Southern Nuclear Operating Company
Vogtle Early Site Permit Application
Response to Request for Additional Information Involving
Limited Work Authorization-2 Supplement

Response to October 26, 2007 RAI Letter No. 9

Vogtle ESP Application Involving LWA-2

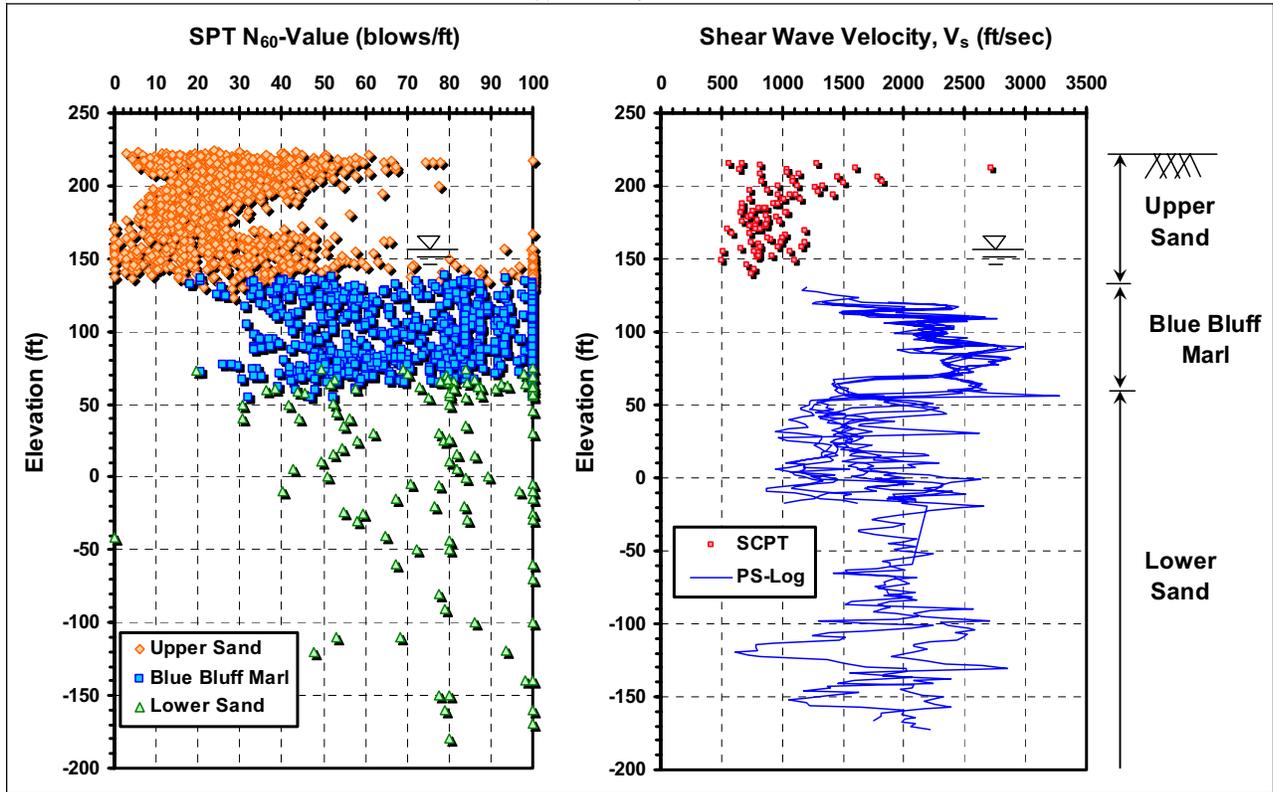
2.5.4-1 Section 2.5.4, page 1, indicates that 174 borings have been taken at the site along with other types of penetrations (presumably Cone Penetration Tests [CPTs], Suspension and dawn-hole velocity loggers, etc.). In reading through the other descriptions provided along with the MACTEC Appendices, the staff was unable to determine how the total of 174 was reached. SNC is requested provide a detailed accounting of these penetrations and how many penetrations will be unusable for the site specific analyses (e.g.. because they were taken through material that is scheduled to be excavated).

In addition to the fourteen ESP borings described in Appendix 2.5A, Appendix 2.5C describes the 174 COL borings. The COL geotechnical investigation, with field work conducted between November 2006 and April 2007, included geophysical surveys and various subsurface penetrations. These penetrations consisted of 174 soil borings, 21 cone penetrometer test (CPTu) soundings, and 8 excavated test pits. The locations of these penetrations are illustrated on Figures 2.5.4-1a and 2.5.4-1b of ESP application Revision 2-S1. Generally, soil boring designators were assigned based on the subject of investigation. A summary is provided in the following table. The exploration depth of each boring varied depending on the existing ground elevation and the anticipated depth of influence of the structure. Exploration depths varied from 21.5 feet to 420 feet. SPT split barrel sampling was generally conducted on a five foot interval. One boring in each power block area was sampled continuously.

Seventy soil borings (two of these were shallow offset borings due to near surface obstructions) were located in the immediate vicinity of the combined excavation footprint for the Units 3&4 power blocks. These included 9 of the 1100 series borings, 32 of the 3000 series borings, and 29 of the 4000 series borings. With the exception of the two offset borings, each of these borings was drilled through the Upper Sand and into the Blue Bluff Marl (BBM). Forty-two of the 70 borings penetrated the BBM and extended into the Lower Sands (LS). Six borings penetrated the underlying Still Branch Formation and two borings penetrated the Congaree Formation. Both of these formations are located in the upper portion of the LS strata. Suspension soil velocity measurements along with resistivity, spontaneous potential, and natural gamma data were obtained in the six deep borings. Caliper and boring deviation data were also collected in these deep borings.

Twenty-one CPTu soundings were taken across the site including four in the combined power block footprint, six in the area of the cooling towers, and the others in roadways and pipeline areas. The data collected at each of these soundings included tip resistance, sleeve resistance and pore pressure dissipation measurements. Eight of the 21 soundings were conducted as seismic cone penetrometer tests

(SCPTu). These soundings were located in the combined power block/cooling tower area. In addition to the CPT data, compression and shear wave velocity data were collected in the SCPTus. Due to the dense/hard layers encountered at the interface of the Upper Sand and Blue Bluff Marl strata, the soundings could not penetrate into the Blue Bluff Marl. Generally, CPTu and SCPTu data collection was limited to the Upper Sand stratum.

Shear Wave Velocity Measurements in the Upper Sand Stratums Measured by COL SCPTu

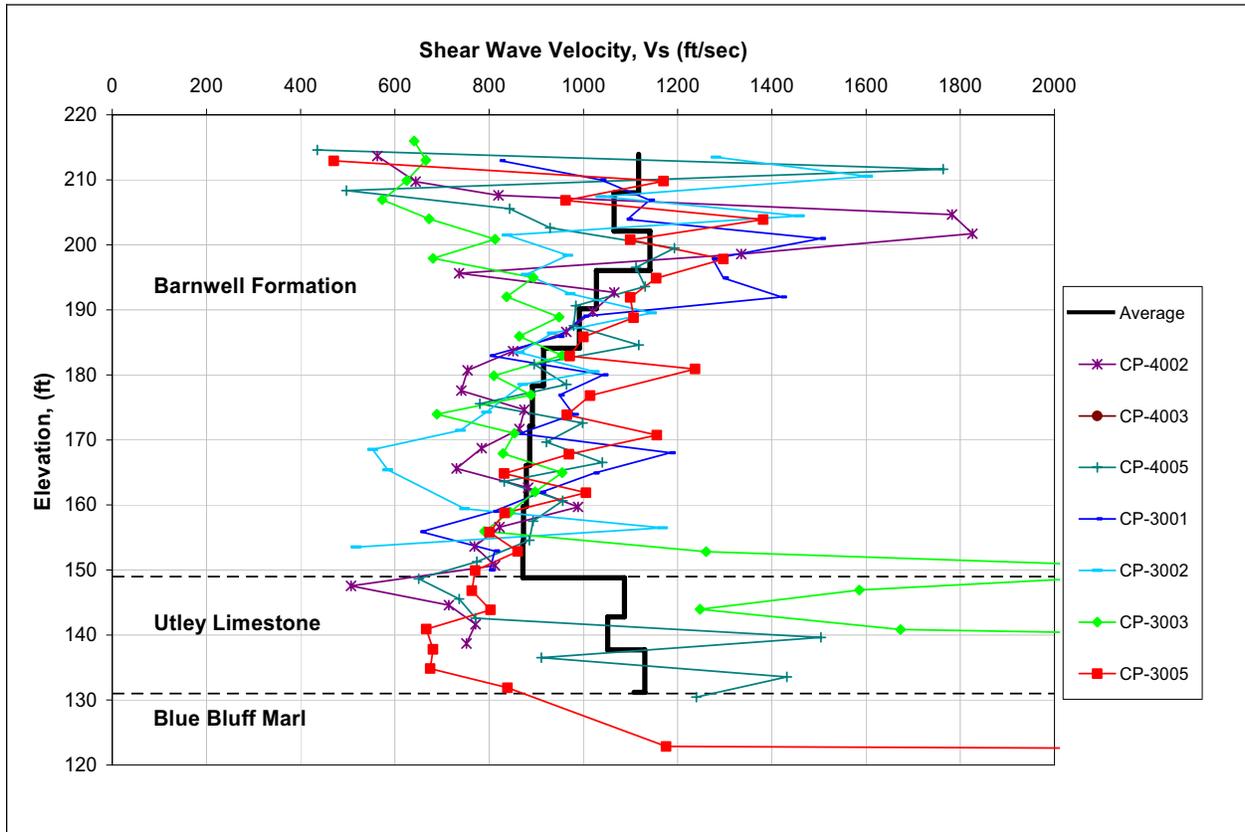
2.5.4-4 Section 2.5.4.2.2.1 indicates that no new strength (and presumably stiffness) testing is to be performed for the Upper Sand Strata since this material is being excavated from beneath the Category I structures. Without additional information, the staff cannot verify SNC's conclusion on the effect of the two-dimensional velocity configuration of the excavated zone on site response and SSI effects. SNC is requested to provide the assessment of the in-situ velocity profile through the Upper Sand Strata for the staff to complete its evaluation.

Shear wave velocity data were collected in the Upper Sand in the power block/cooling tower area. Eight SCPTu soundings were taken as described in the above response to RAI 2.5.4-1. The shear wave velocity measurements from seven of these soundings along with the average velocity profile are presented on the figure below. The data from the eighth sounding, C-4001, was not plotted and incorporated into the average value. In this sounding velocity values of 4,000 fps were encountered at the top and bottom of the US stratum and the data were judged to be unreliable.

Plot of N_{60} and Fines Content with Elevation – Borrow Area 4

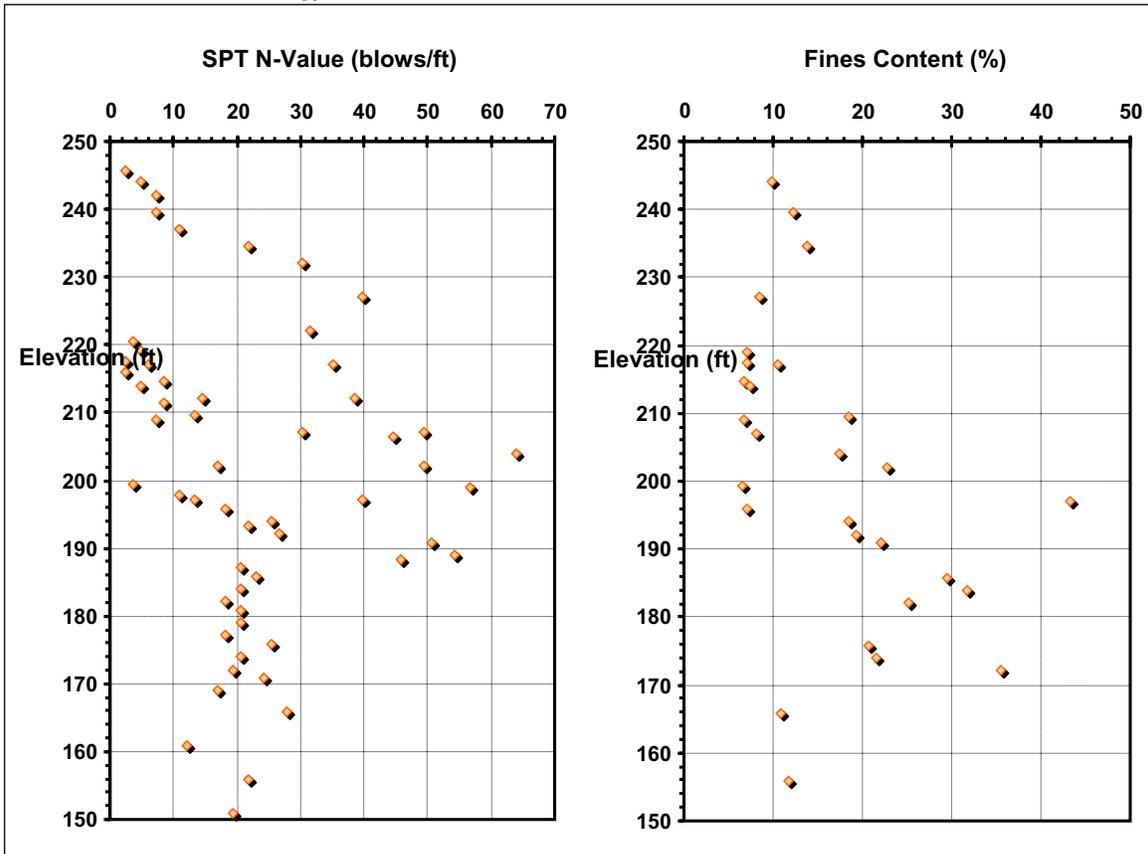
2.5.4-10 Section 2.5.4.5.3 states that approximately 3.9M cubic yards of material will be excavated for the power block area and that approximately 3.8M cubic yards will be required as structural backfill. Only about 30% of the excavated material will be suitable for reuse as structural backfill. An additional 2.5M cubic yards will be required and therefore, SNC is requested to perform additional investigations and testing, using horizontal and vertical intervals sufficient to determine material variability of the borrowed soil.

During the Units 3 & 4 COL geotechnical investigation, the alternative borrow source, Borrow Area 4, located about 4,000 feet north of the power block area was explored with four SPT borings and three test pits. This area was previously explored but not utilized during the design and construction of Units 1 and 2. Results of the COL field and laboratory test are summarized in the figures and table below.

Presentation of test results for soils at Borrow Area 4: (a) SPT N_{60} -value; (b) Fines content (MACTEC, 2007).

Modulus Reduction Curves for EPRI and SRS Models

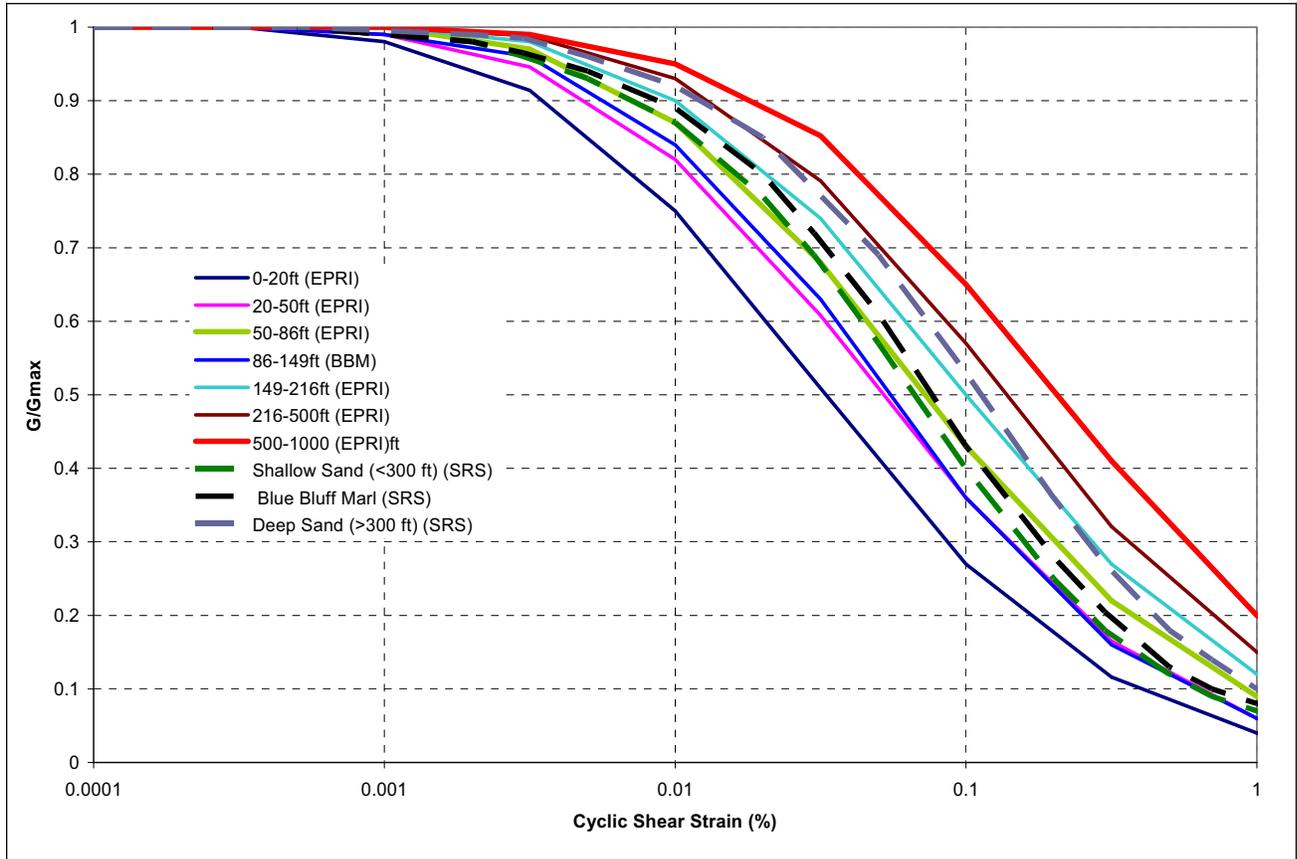
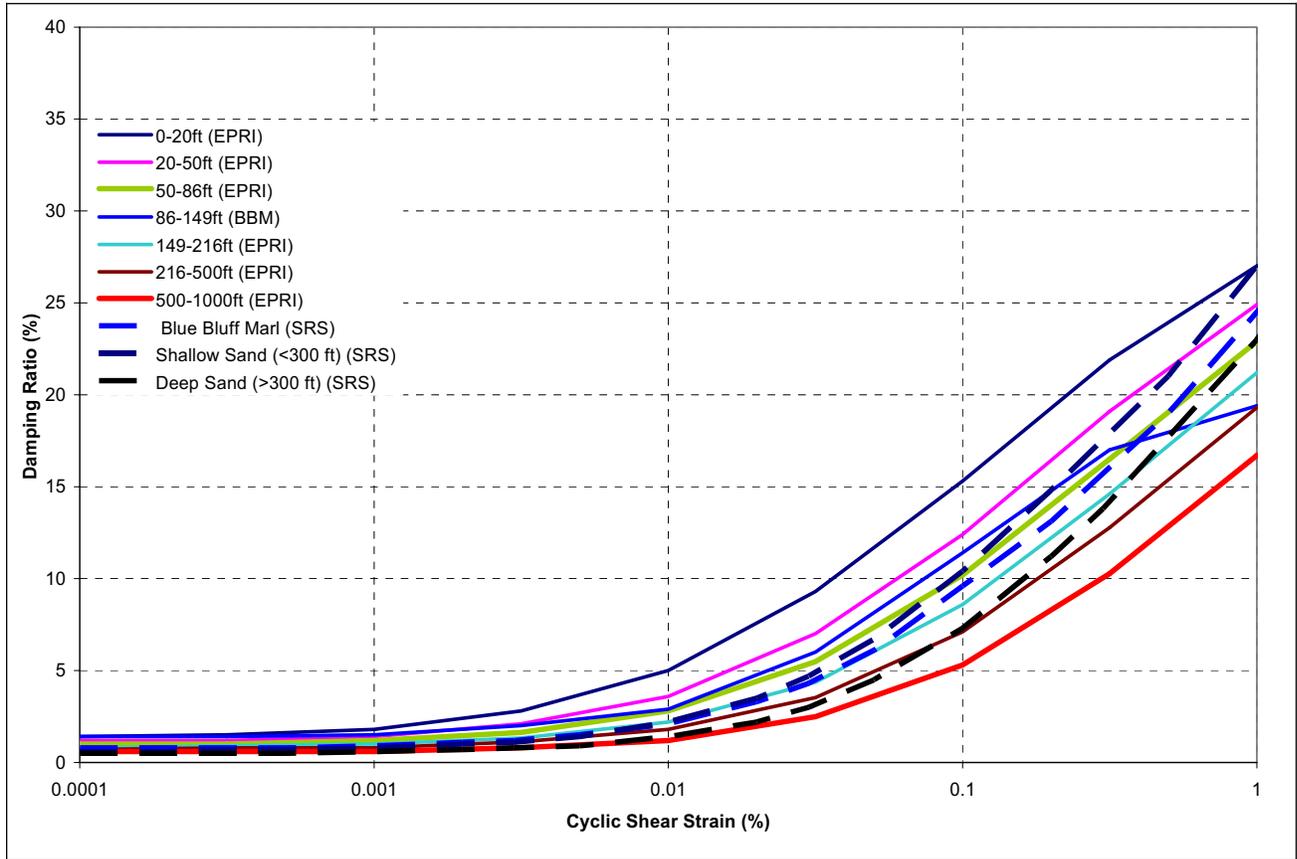
- 2.5.4-16 In Subsection 2.5.4.7.1, SNC discussed the shear wave velocity profile to characterize the site, but the discussion did not cover the backfill material. In Subsection 2.5.4.7.2, SNC described EPRI 1993 soil degradation models as well as SRS models. However, no significant discussion is presented of how these two models compare, which is more appropriate to use for Vogtle site response analyses, and how significant the models are to both site response and SSI analyses. SNC is requested to address these three issues.**

2) ESP application Subsection 2.5.4.7.2 discusses shear modulus and soil damping for the compacted backfill, BBM, and Lower Sand strata. These subjects were further discussed in the March 15, 2007 response to RAI 2.5.4-17. These discussions included descriptions of which EPRI curves were used to derive the soil degradation values for input to the SHAKE analysis. Soil degradation values from the neighboring SRS site were also used for input to SHAKE. Figures 2.5.4-9 and 2.5.4-11 in the ESP application illustrate the EPRI soil degradation values, while Figures 2.5.4-10 and 2.5.4-12 illustrate the SRS soil degradation values. The modulus reduction curves for EPRI and SRS have been plotted together in the figure below to illustrate the relationship between these models. Likewise, the same has been done for the damping ratio curves. Note that the SRS curves were selected based on their stratigraphic relationship to the Vogtle 3 and 4 site. The SRS curve labeled as Blue Bluff Marl on the figures below is

based on the Dry Branch Formation and the Santee Formation, the SRS stratigraphic equivalent to the Vogtle Blue Bluff Marl. Both data sets were used to include variability in the model and each is weighted equally. RCTS testing is currently being conducted to develop site-specific data. When these data become available, the results will be evaluated and the site response analysis will be re-run if appropriate.
